Detailed Site Plan

DSP-09013-01

DPLS-473

Quincy Manor

SITE PLANS

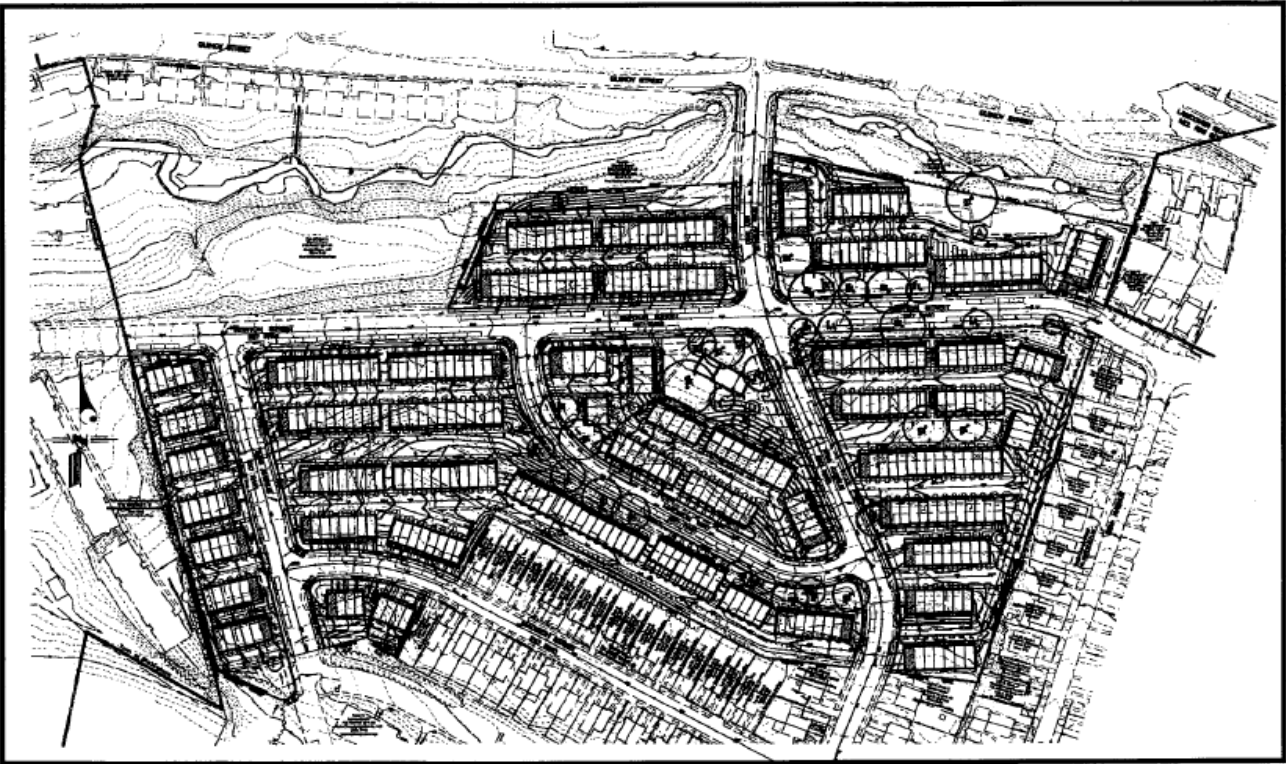
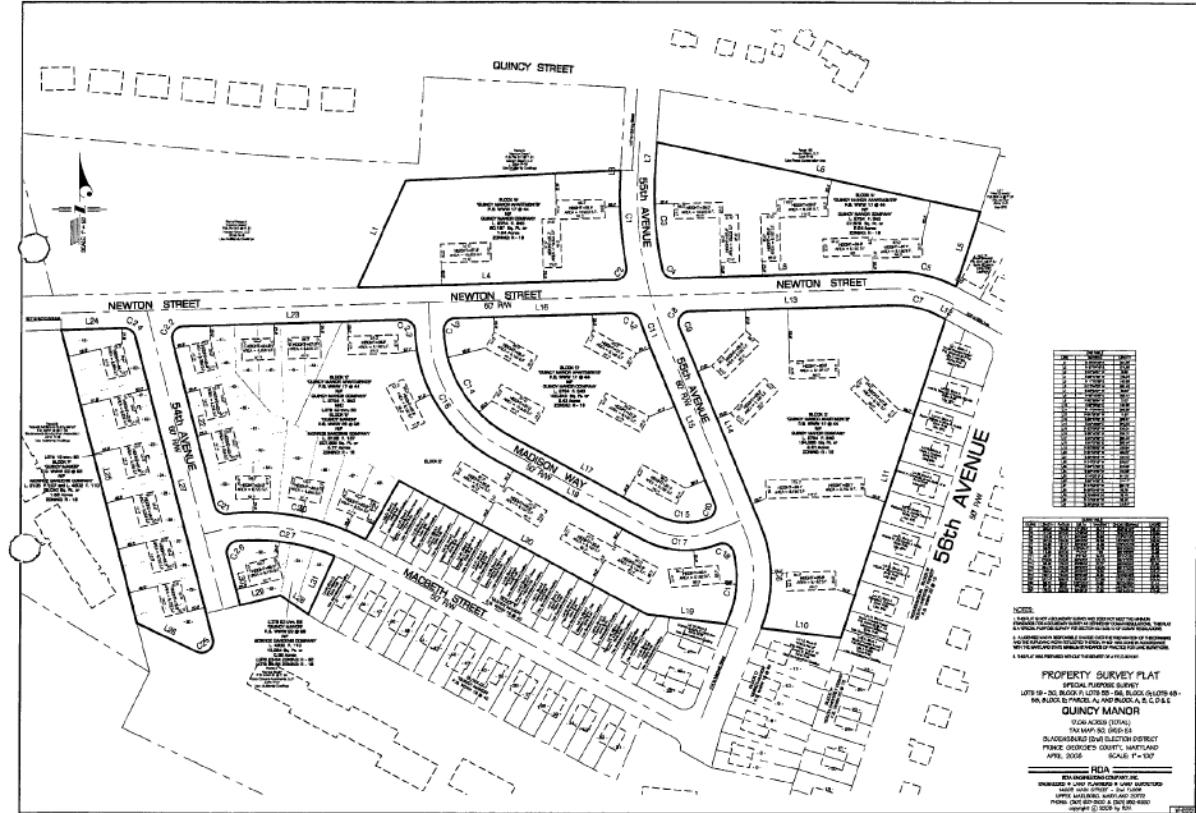
6. **Design Features:** This DSP application seeks to remove the recorded townhouse lots and revert the entire site to a larger parcel layout to reflect the existing on-site brick multifamily residential buildings. No development is proposed with this application.

The original DSP approval, DSP-09013, proposed to raze the existing multifamily buildings and develop the site with townhouses. The townhouse lots were recorded as referenced above and a community building was constructed as part of that proposal vesting the detailed site plan on the property, however, the multifamily development was never razed. The applicant has submitted the subject DSP revision, with companion DPLS, and variance applications, to remove the townhouse development and proposes to vacate the townhouse preliminary plan of subdivision in order to retain the existing multifamily buildings and divest the property of any conditions, rights or responsibilities associated with the PPS approval.

1. Prior to certificate of approval of the DSP, the plans shall be revised to provide accurate plat recording references for the areas included in the site.
2. Prior to certificate of approval of the DSP, the vacation process shall be complete and a final plat incorporating the vacated area shall be approved.
